8538 RIVER DISTRICT CROSSING - "Parcel 17"
(COMPLETE APPLICATION)
DE418325 - ZONE CD-1

DEVELOPMENT PERMIT STAFF COMMITTEE MEMBERS

DEVELOPMENT PERMIT STAFF COMMITTEE RECOMMENDATION: APPROVE

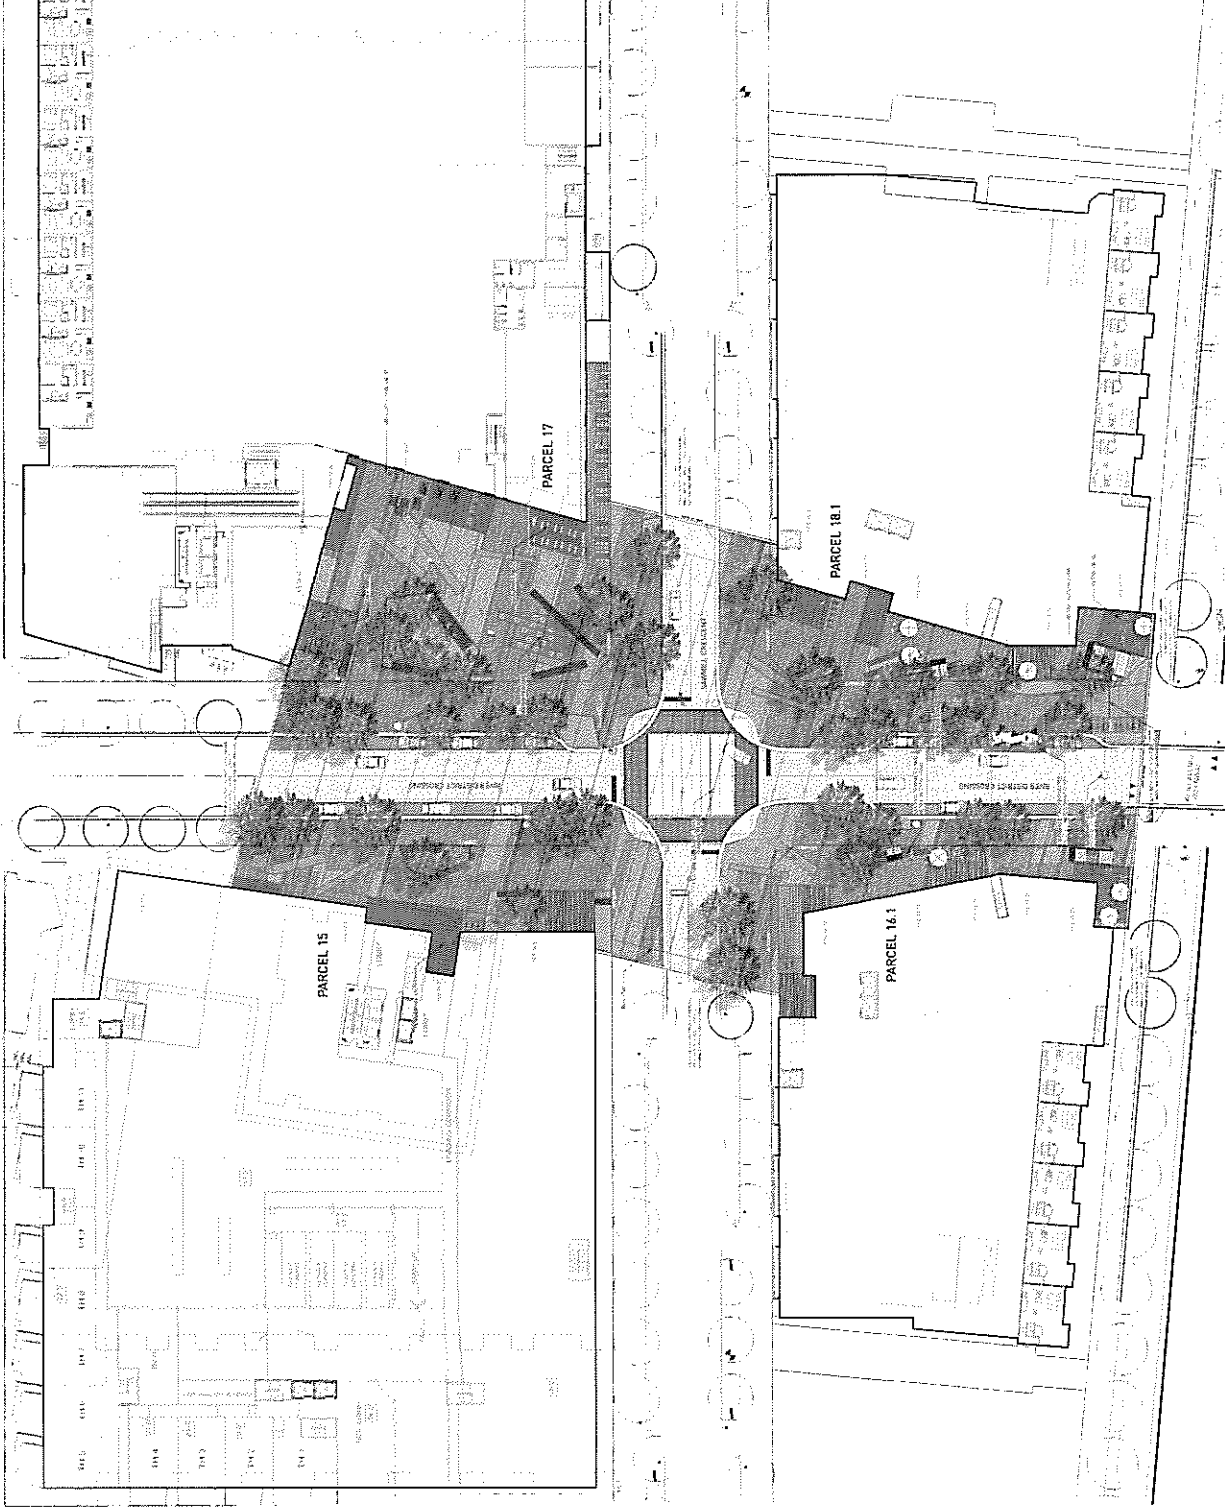
Note to Applicant: With emphasis on the Town Square and the podium level. Sheet L2.0 and LDP1.01 should be further detailed.

A.2.26 relocate the trash receptacle shown on drawing LDP1.01 onto private property;
